MEMORANDUM

Subject: Spalding Community Services District
Sewer Lift Station Evaluation

Date: November 4, 2024

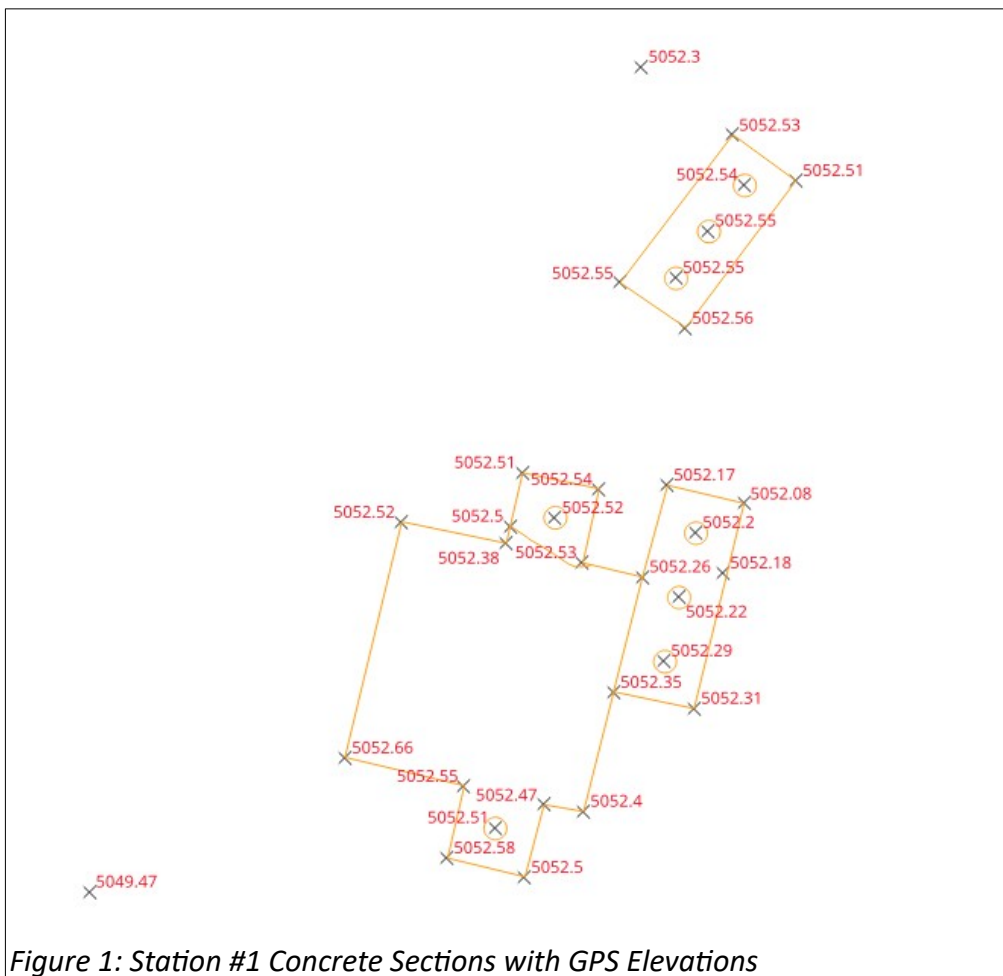
The general areas of settling can be interpreted from Figures 1 and 2 which show the elevations of edges of concrete and center of manholes for Stations 1 and 2 respectively. At station #1, measurements show that the concrete slab around the pump wet wells is typically about 0.2 -0.3 ft lower than the western edge of the generator slab and the slab over the valve vault. For Station #2, differences in elevation between the various slabs is minimal. Although Station #4 was not surveyed, the visual evidence of the settling issues is very apparent. In some ways, the issues at Station 4 are more problematic because portions of the station were

The slab supporting the generator and controls does demonstrate some differential settlement. Figure 1 shows that the generator slab is showing a slight slope toward the direction of the pump wet wells. Elevations are lower in the northeast direction and higher towards the southwest.
